NOTICE OF ADDENDUM

ADDENDUM NO. 2

CONTRACT NO. 6871

Door Creek Culvert

SHEET NUMBER:
G-1

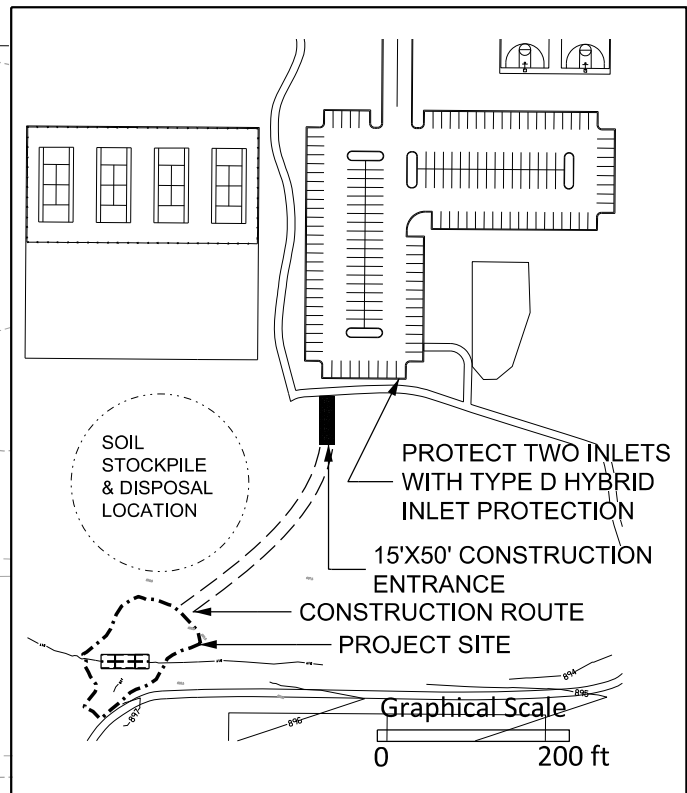
- Replace Sheet G-1 with Revised Sheet G-1
 - Revise Note: "All disturbed areas within grading limits (as shown on plans) shall received Class I, Urban Type A erosion control matting, unless otherwise indicated for Class III, Type C TRM". Disturbed areas outside of grading limits shall be fertilized, seeded and mulched.

1. ALL DISTURBED AREAS WITHIN GRADING LIMITS (AS SHOWN ON PLANS) SHALL RECEIVE CLASS I URBAN TYPE A EROSION CONTROL MATTING, UNLESS OTHERWISE INDICATED FOR CLASS III TYPE C TRM. DISTURBED AREAS OUTSIDE OF GRADING LIMITS SHALL BE FERTILIZED, SEEDED AND MULCHED.
2. ALL AREAS IDENTIFIED FOR CLASS III TYPE C TRM SHALL BE SEEDED WITH WETLAND RESTORATION SEED MIX AND COVER CROP. ALL OTHER DISTURBED AREAS SHALL BE SEEDED WITH CITY OF MADISON STANDARD SUN TERRACE MIX AND COVER CROP.
3. ALL EXCAVATED MATERIAL TEMPORARILY STOCKPILED ON SITE, SHALL HAVE SILT SOCK PLACED ALONG THE DOWNHILL SIDE OF THE STOCKPILE.
